Job Sheet 168274

Part Name: Strut Bracket

APICAL INDUSTRIES, INC.	ENGINEERING CHANGE NOTICE NO. 03985			SHEET 1 OF 2	
	DWG NO. 647.0100	REV: A	PREPARED BY J. BECKER	DATE: 7/15/13	EFFECT ON DWG ☐ INC. ☒ UNINC.
	DWG TITLE: SHEET METAL				
	APPROVED BY: ENGR 	MFG 	QC 	EFF. NEXT ORDER	
TRANSACTION CODES (TC): A-ADD R-REVISE C-CREATE D-DELETE	REASON: REVISED NOTE 2. ADDED 647.0117

SHEET 1, ZONE D1 IS:

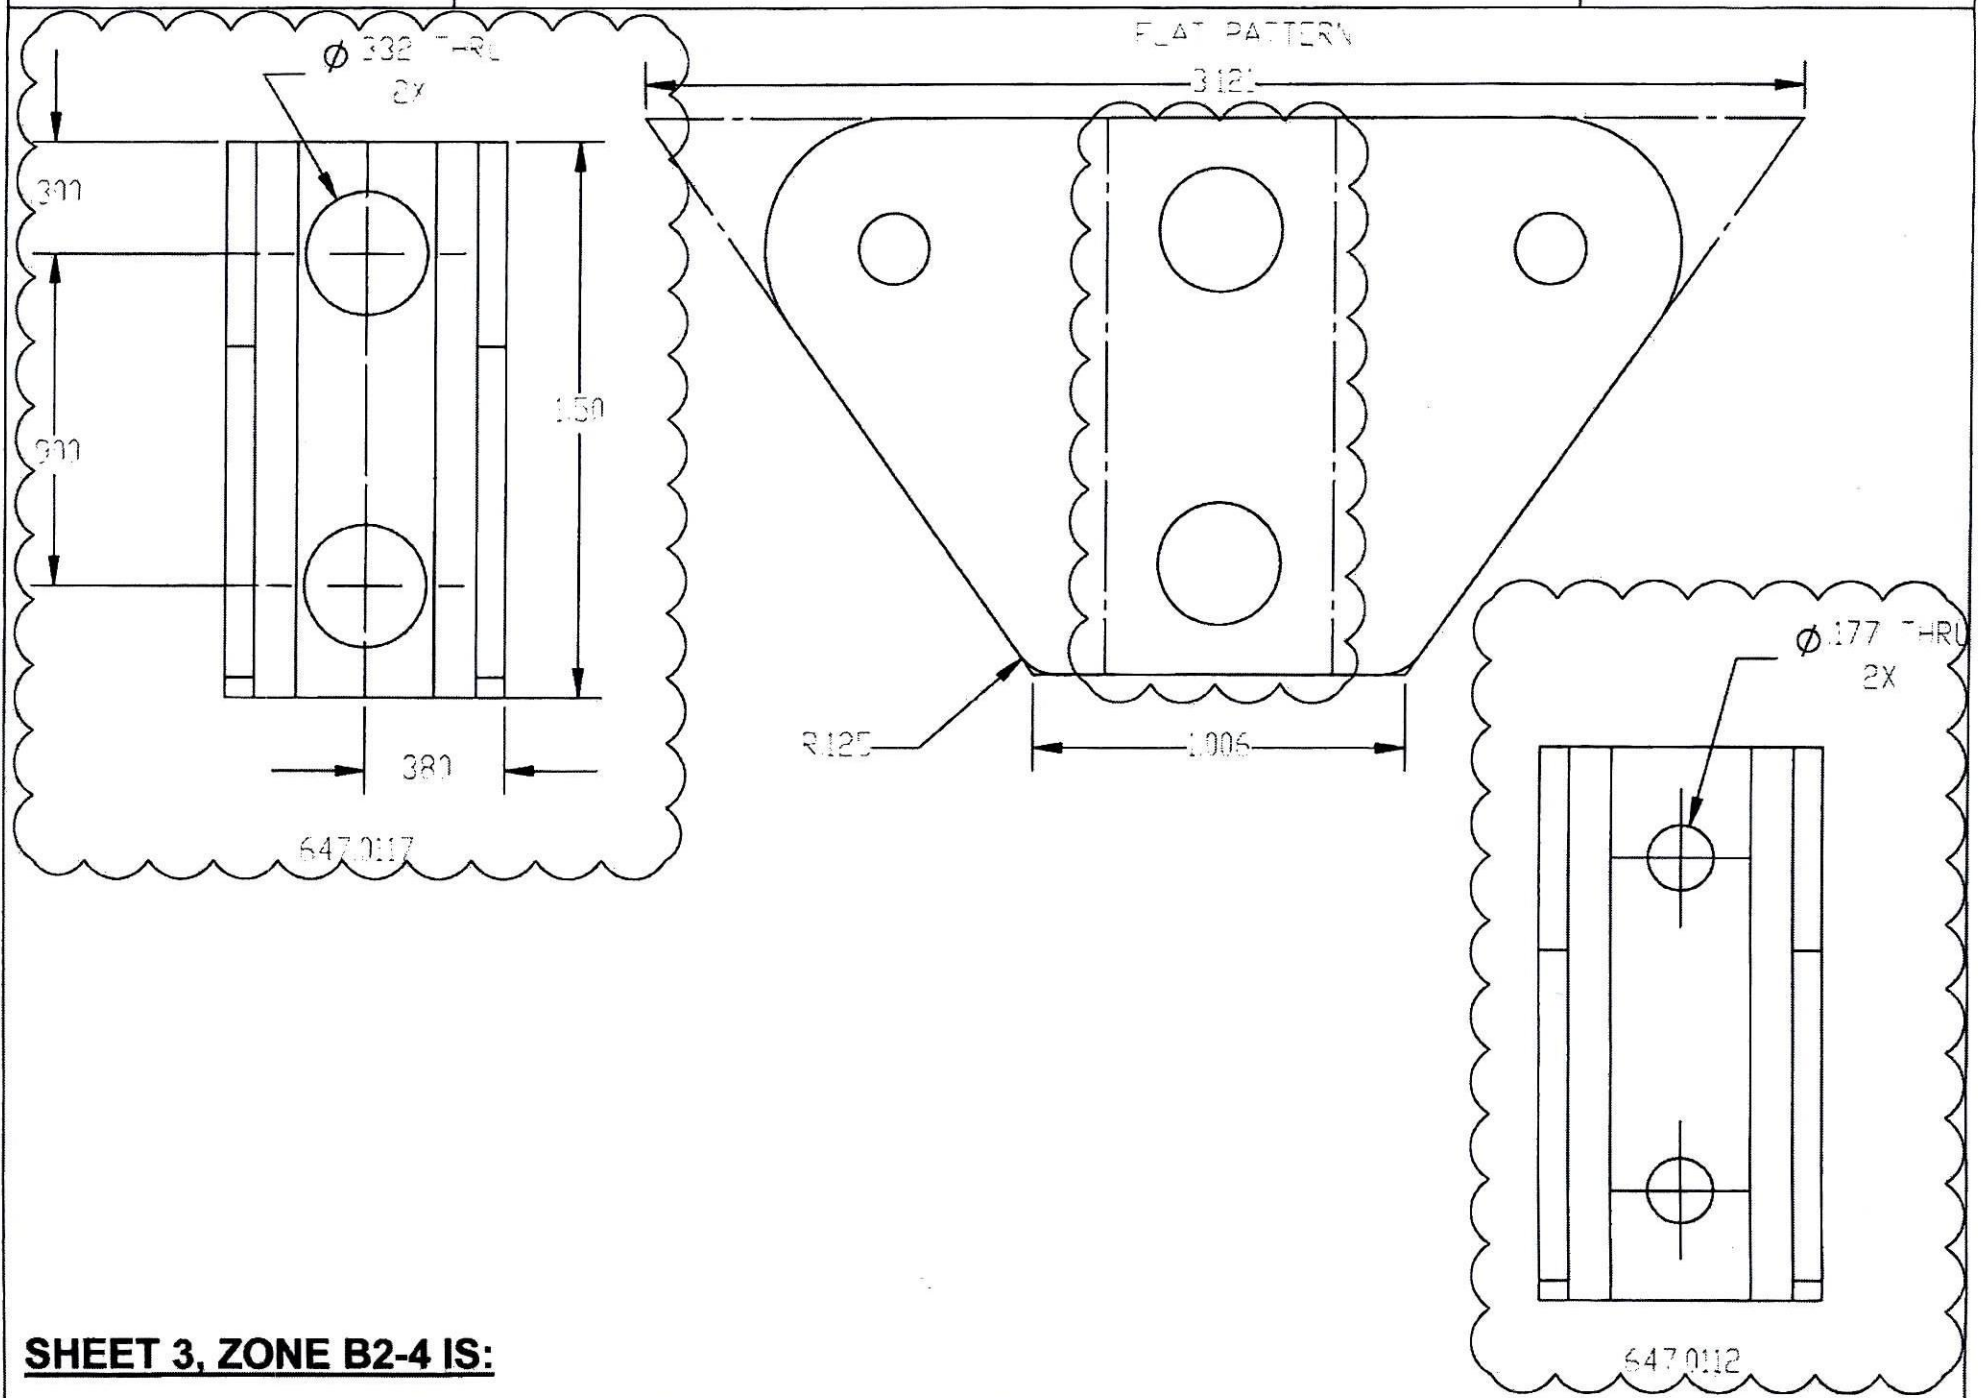
- 1 MATERIAL: ALUMINUM 2024-T3 PER AMS-QQ-A-250/4.
- 2 FINISH: IAW MPP-172 ANODIZE IAW SECTION 2.1,
PRETREATMENT IAW SECTION 3.1
AND PRIMER IAW SECTION 4.1.
3. DEBURR AND BREAK ALL SHARP EDGES.
4. IDENTIFY IAW MPP-120.
- 5 MATERIAL: 304 SS IAW AMS 5643.
- 6 FINISH: PRIME IAW MIL-P-23377J TYPE I CLASS N.
- 7 OTHER DIMENSIONS SAME AS 647.0112.

C	647.0117	STRUT BRACKET		△	△
F/NTC	PART NUMBER	DESCRIPTION		MATERIAL	SPECIFICATION
DOCUMENTS EFFECTED:		CHANGE CATEGORY		DER REVIEW REQUIRED	
☐ MDL ☐ INSTALL INSTRUCTIONS ☐ ICA ☐ FMS ☐ BOM		☐ MAJOR ☒ MINOR		☐ YES ☒ NO
